Jan 2026 MDG Proposed Updates

Revision Type	Reference	Section Description (Red indicates Change of name from existing)	Description of Revision	New or Deletion	Primary POC
MDG	ALL Chapters	MANY	Editorial update throughout MDG to change "Shared Use" to "Shared-Use" to be consistent with MUTCD		Alford / Fiant
MDG	1.4	Definitions	Updated definitions for consistency with MUTCD		Alford
MDG	2.3.1.1	Planning Resources	Updated Streetlight Data Row to indicate account access provided through Office of Planning rather than Office of Roadway Engineering. Also, removed safety data available timeframe years in Walk.Bike.Ohio row.		Alford
MDG	Table 3-2	Mean Walking Speeds for Disabled Pedestrians and Users of Various Assistive Devices	Corrected walking speed for Above-knee amputee row in table		Alford
MDG	Figure 3-3	Example of Mutual Yielding Zones Illustrating Intersection Sight Distance Case A	Update figure to show current MUTCD bike symbol marking		Alford

Figure 8-3: Accessible Pedestrian Pushbutton Locations with Separated Bike Lane

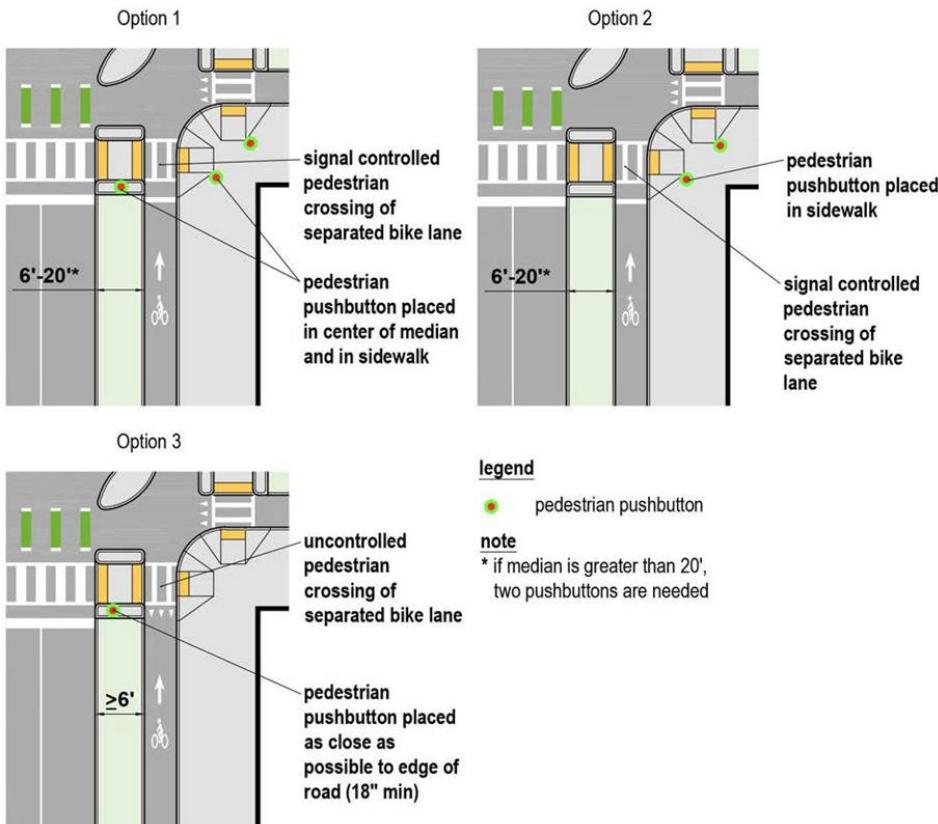
Commented [KF1]: Update to show new Bike Symbol per MUTCD

Figure 8-7: Pedestrian Hybrid Beacon at High Volume Major Road

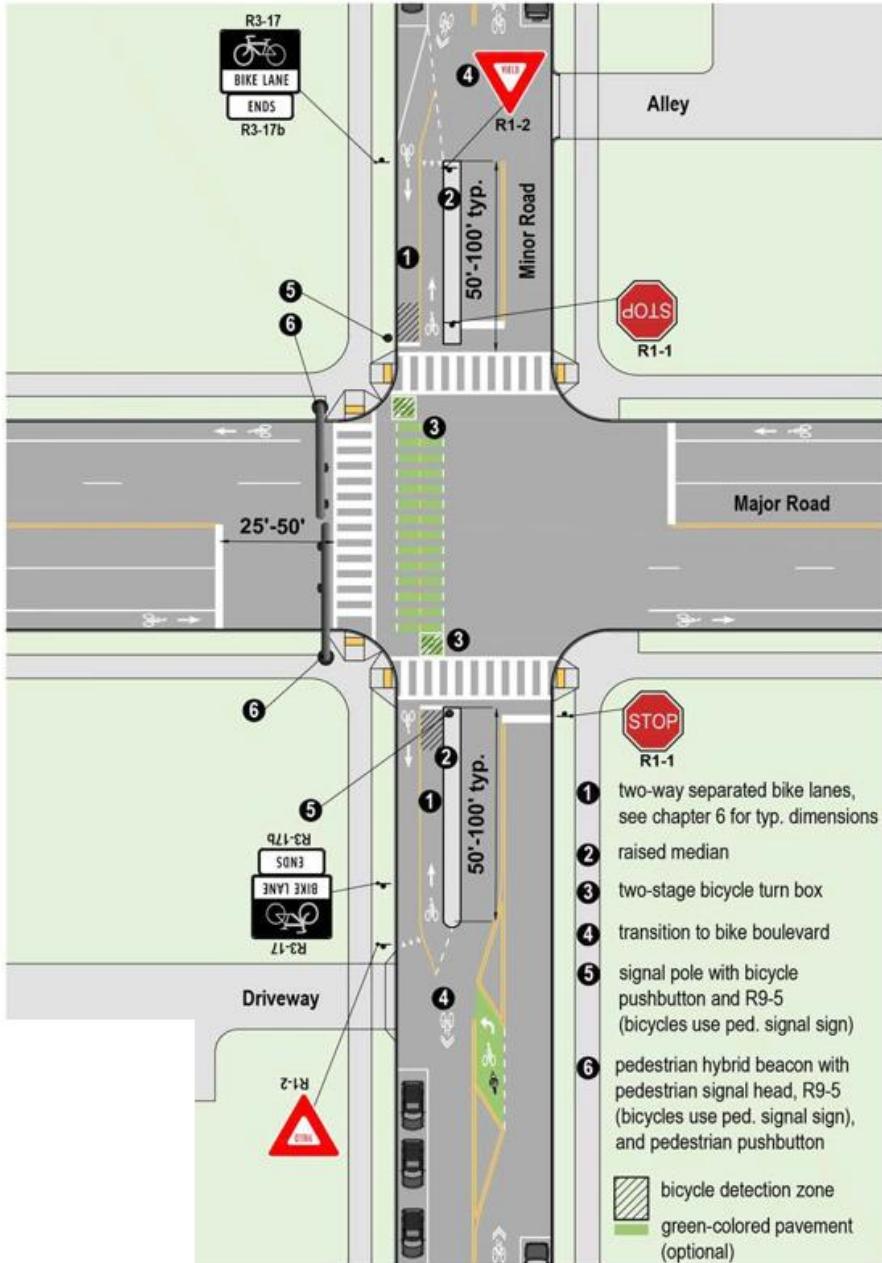
Commented [KF2]: Update to show new Bike Symbol per MUTCD

Figure 9-2: Bike and Pedestrian accommodations at free-flow exit ramps

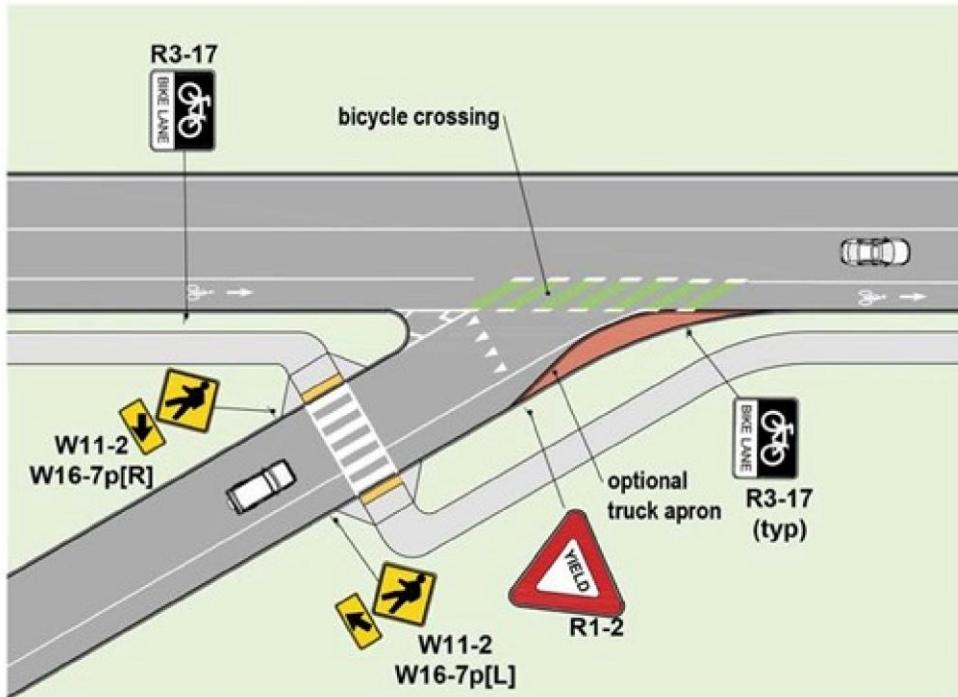
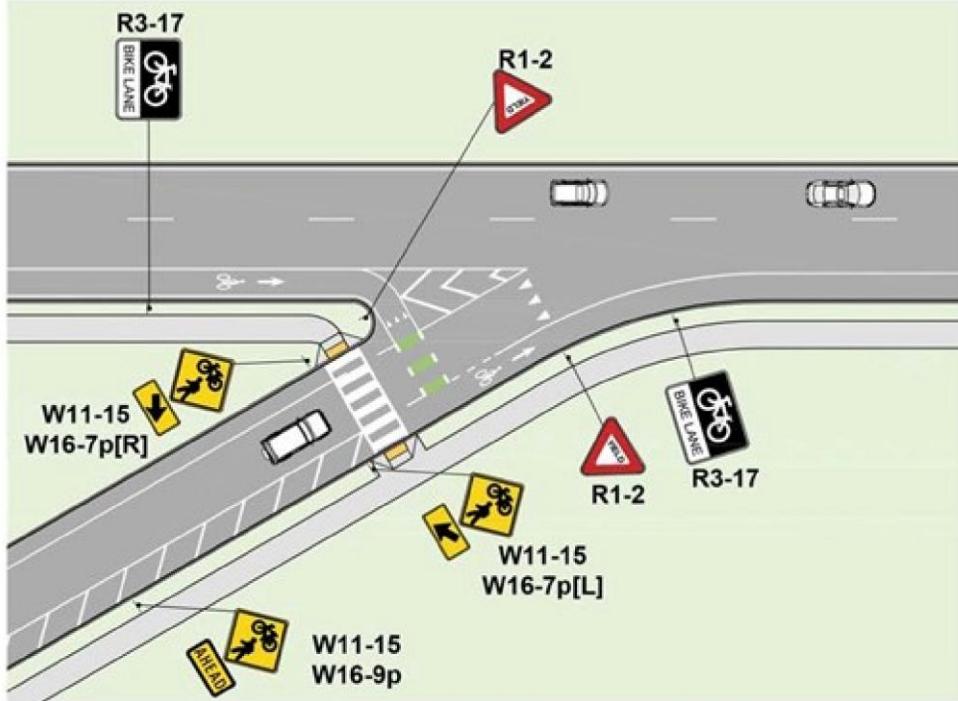
Commented [JW4]: Bike symbol to be updated per
MUTCD

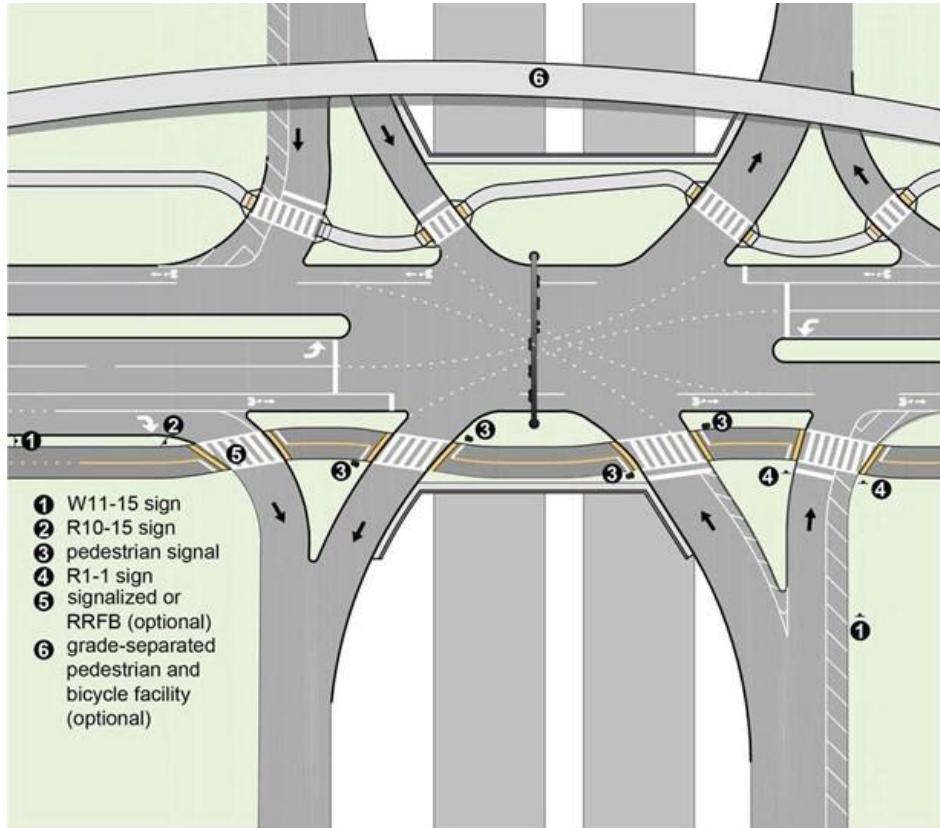
Commented [KF5]: Bike symbol to be updated per MUTCD

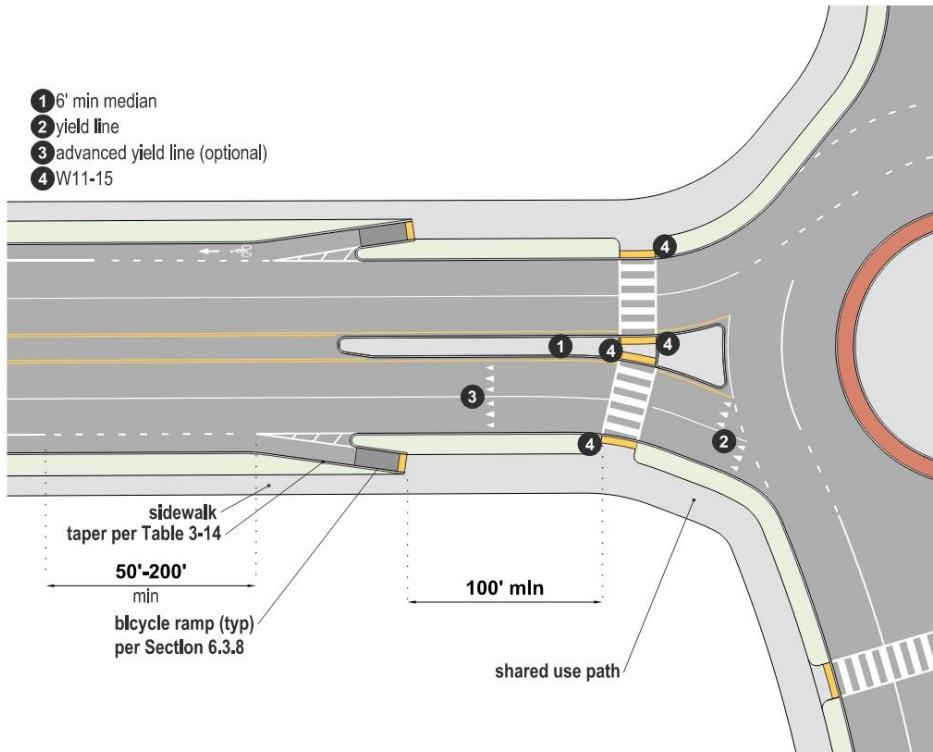
Commented [JW7]: Bike symbol needs to be updated per the MUTCD

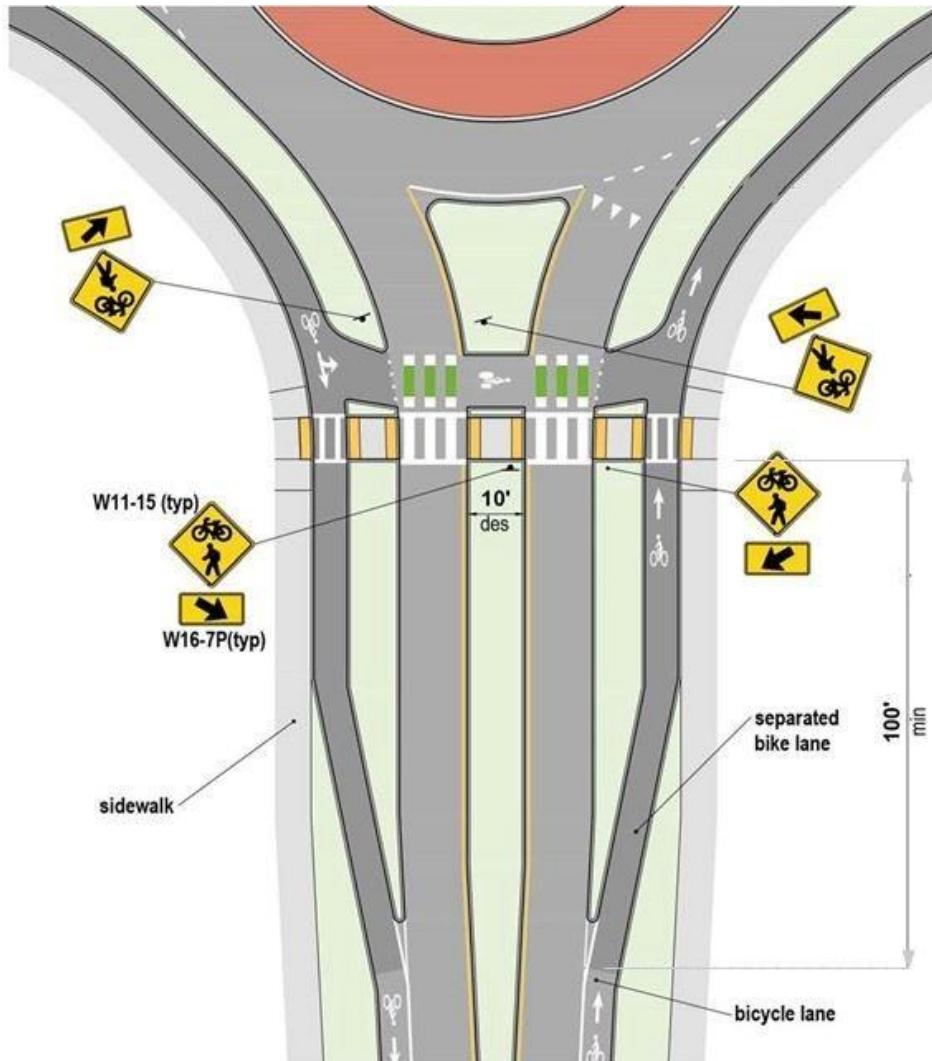
Commented [JW8]: Bike symbol needs to be updated per the MUTCD

FLOATING BUS STOP DETAILS

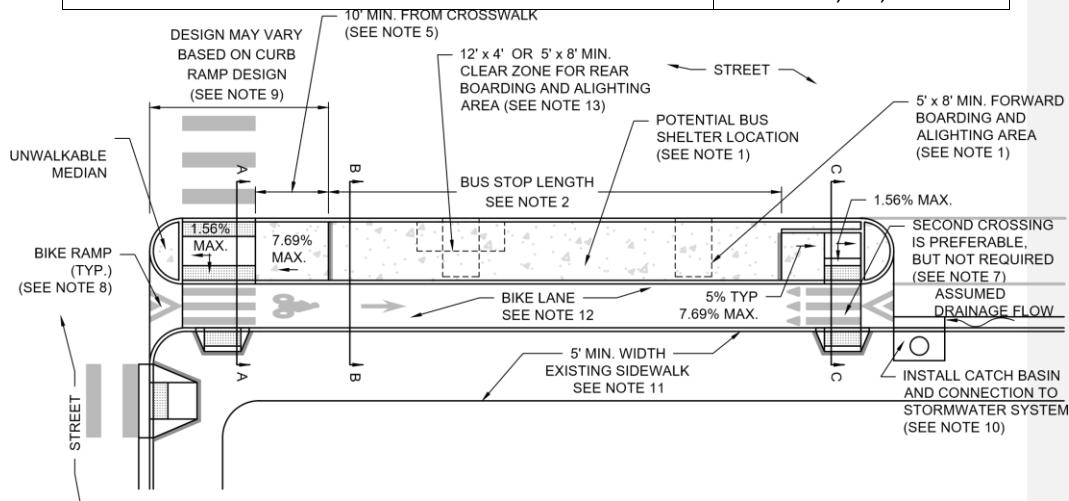
MDG	DWG 10-1.5	FLOATING BUS STOP DETAILS	Bike symbol needs to be updated per MUTCD. The speed hump marking on the right side of the platform is pointed the wrong direction and should be pointed the same direction as the marking on the left side.		Alford
MDG	Many	Many	Update Figure callouts with removal of some Figures within chapter		Alford
MDG	11	Rail Crossings	Update intro paragraph to refer to OMUTCD Chapter 8 for Rail Crossing info in MUTCD.		Alford
MDG	11.1	Provision of Access and Design for Pedestrians and Bicyclists	Delete the following, "Section 5.1.3 discusses the provision of pedestrian facilities based on context and" in first paragraph and updated other MUTCD references.		Alford
MDG	11.1.1	Accessible Design at Rail Crossings	Add OMUTCD references and updated Detectable Warnings section to match PROWAG		Alford

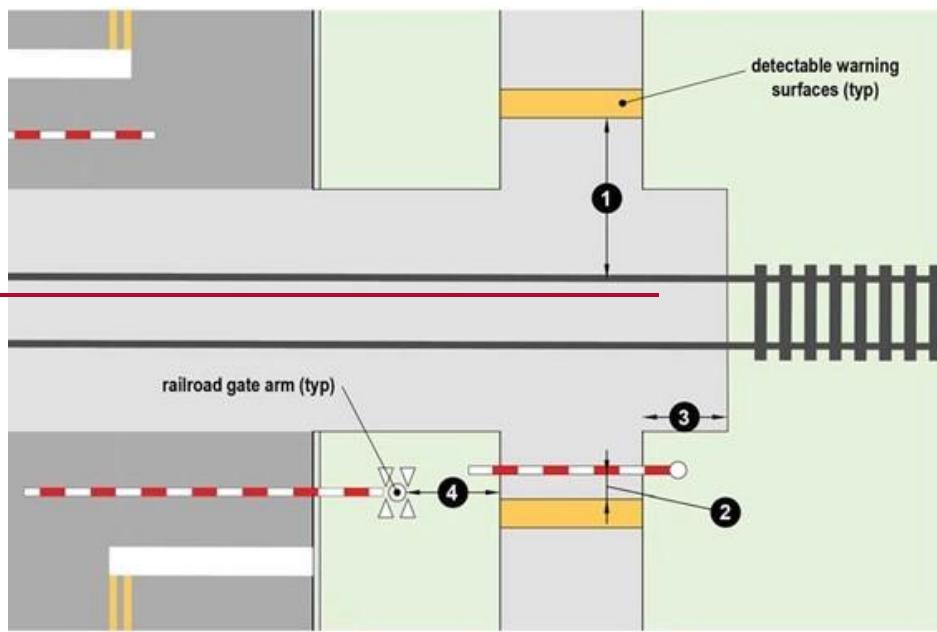
Commented [KF1]: Delete Figure

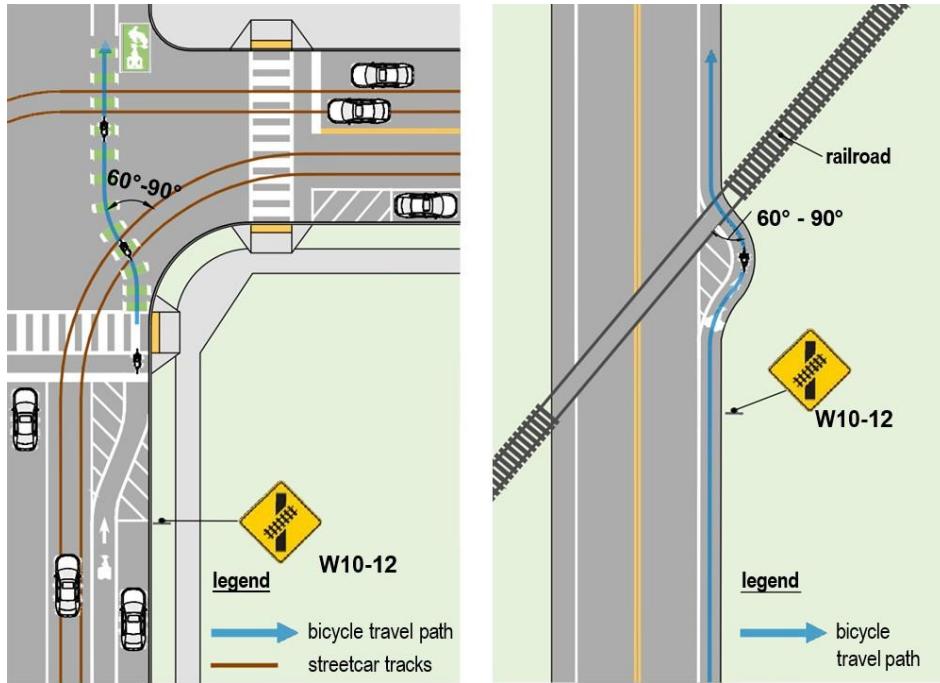
Commented [DH2]: Update bike symbol

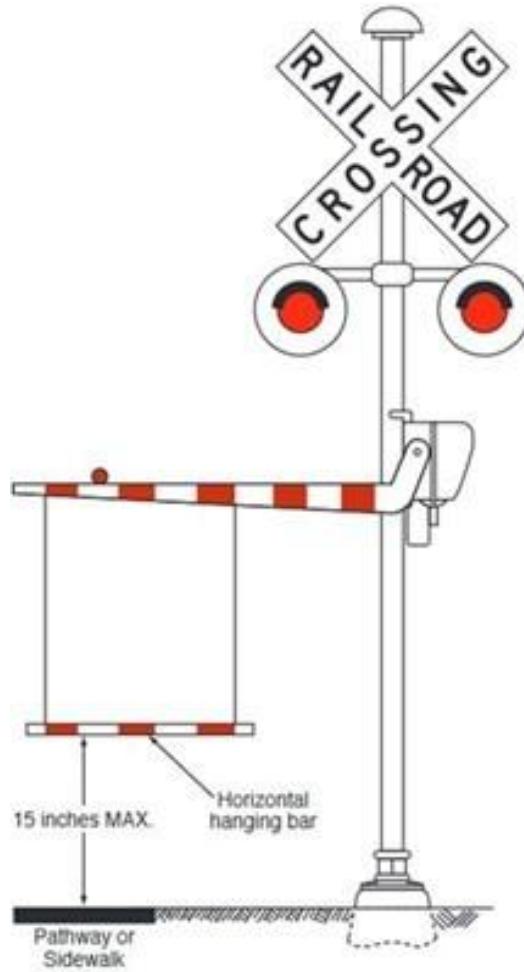
Commented [JB6]: Recommend replacing this with Figure 8E-12 in 11th Edition.
